Raleigh Historic Development Commission – Certificate of Appropriateness (COA) Application

Section/Page	Topic	Brief Description of Work (attach additional sheets as needed)
Sect4.1/53 Decks		
		The owners are proposing stained deck posts with horizontal cable rails for their new deck that was approved in a prior major work COA application. The deck and posts will be stained and the rails will be part of a more formal aesthetic for the deck see attached photos of what the deck will look like an
		other examples throughout the neighborhood.
	·····

613 Polk St Proposed Deck Rails

523 Lane St - Oakwood example of deck with horizontal rails w/ similar deck location

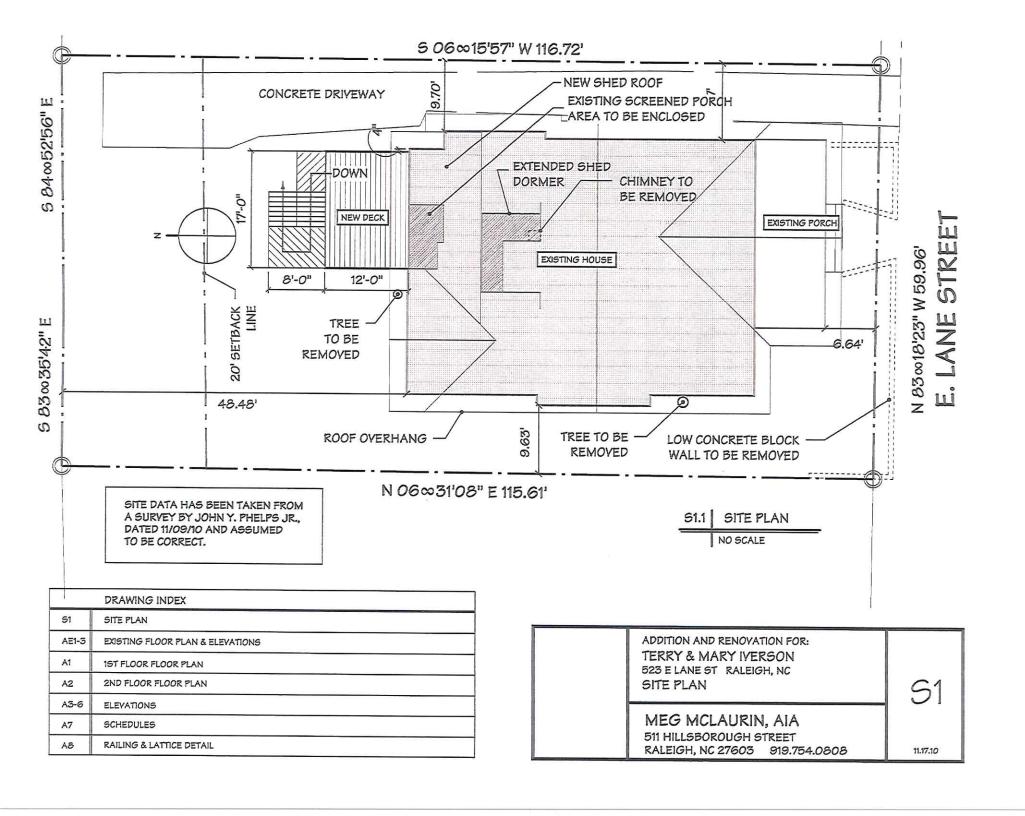
- C. Removal of existing rear stairs; construction of rear deck with copper pipe railing is not incongruous in concept according to *Guidelines* sections 2.3.7, 4.1.1, 4.1.2, 4.1.3, 4.1.5, 4.1.6, 4.1.7, 4.1.8.

- 1* There are no trees in the footprint of the proposed deck; there are trees at the edge of and/or on adjacent properties that may have roots extending into the footprint of the deck and which may be impacted by construction activity.

- 2* The deck is located on the rear elevation and aligns with the first floor of the house.
- 3* The proposed deck is constructed of wood as is commonly approved in the district.

- 4* Deck details including the railing and lattice were included in the application.
- 5* The committee has approved railings with horizontal pickets on rear decks (058-07-CA, 516 Polk Street) when in locations not prominently visible from the street; copper is a traditional material.

Staff suggests that the committee approve the application, waiving the 365 day demolition delay for removal of tree with the following conditions:

Mr. Belledin moved to approve the application, adopting the staff comments as the written record of the summary proceeding on 151-10-CA. Mr. Shackleton seconded the motion; passed 4/0.

COA Application Addendum for 516 Polk Street - Oakwood.

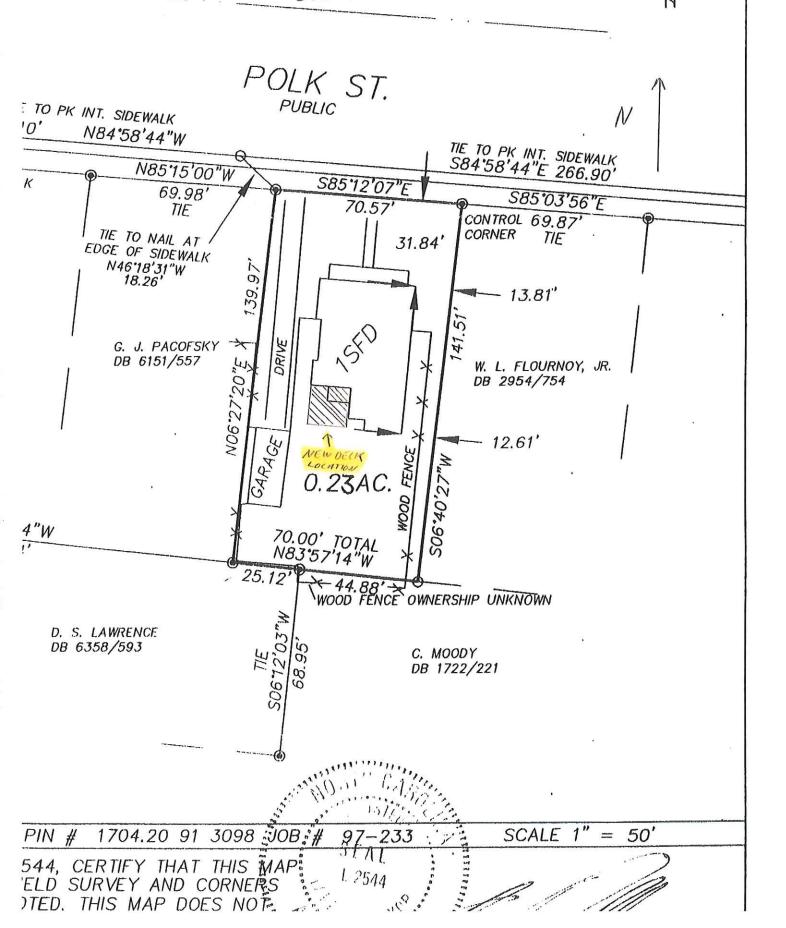
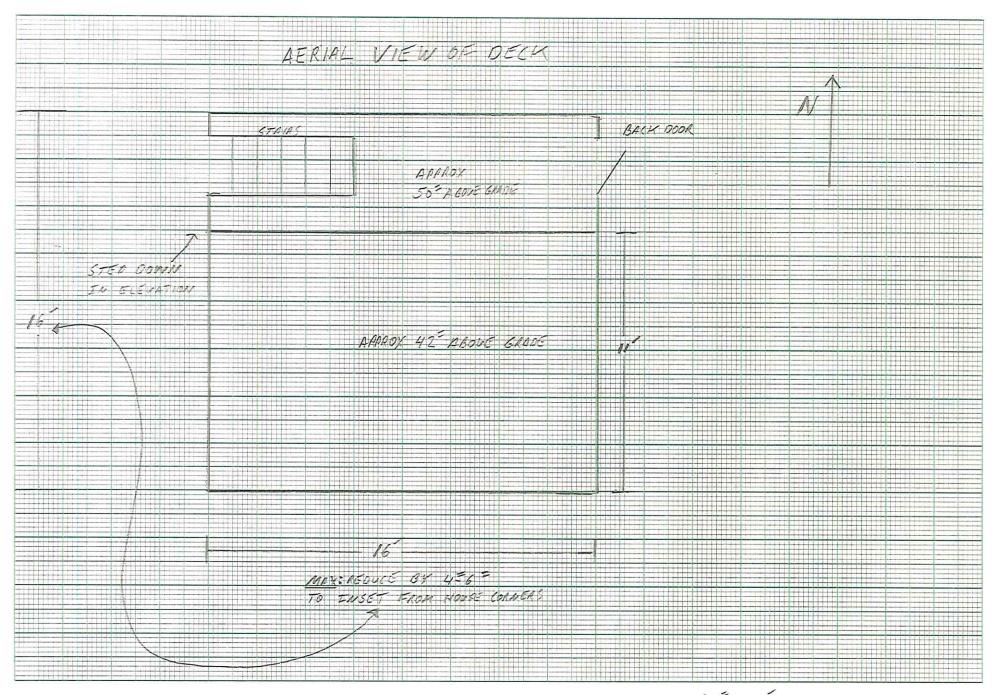
- D. Constructing a rear deck is not incongruous in concept according to *Guidelines* sections 4.1.1, 4.1.2, and 4.1.5. However, the use of metal railing may be incongruous according to *Guidelines* section 4.1.3.

- 1* The proposed deck location is off of the rear elevation of the structure, an unobtrusive location behind a tall privacy fence.
- 2* The proposed highest point of the deck (50") is the height of the house foundation and is level with the first floor of the house. The deck steps down 8" in height as it extends south towards the rear yard. Deck configurations with variations in height have been previously approved by the committee given the reversible, contemporary nature of decks.

- 4* The use of metal tube railings does not reflect the historic materials of the structure. Guidelines section 4.1.3 states "Design and detail decks and associated railings and steps to reflect the materials, scale, and proportions of the building."

- 5* Section 4.3, New Construction, intro paragraph, states "...the introduction of a compatible but contemporary new construction project can add depth and contribute interest to the district."

- 6* The metal tube construction of the railing is no more visually intrusive and obtrusive than the wooden top rail when viewing the house from the yard, as well as when viewing the yard from the house.

- 7* Evergreen bushes are proposed to screen the base of the deck.
- 8* At the March 5, 2007 meeting, the committee conditionally approved a metal and cable railing on rear decks at 510 Polk Street (026-07-CA). The committee found that in that situation the cable railing proposed was being applied to a modern deck in a location fairly hidden from view. The file is available for review.

Mr. Cruse made a motion that the amended application be approved, with the following conditions:

- 1. That prior to issuance of building permits, staff review and approve details for:
 - Decking material and dimensions, supports, edges and choice of material tubing or cable.
- 2. That the deck be inset 6" from the west elevation.
- 3. The fence must remain as long as the railing remains.
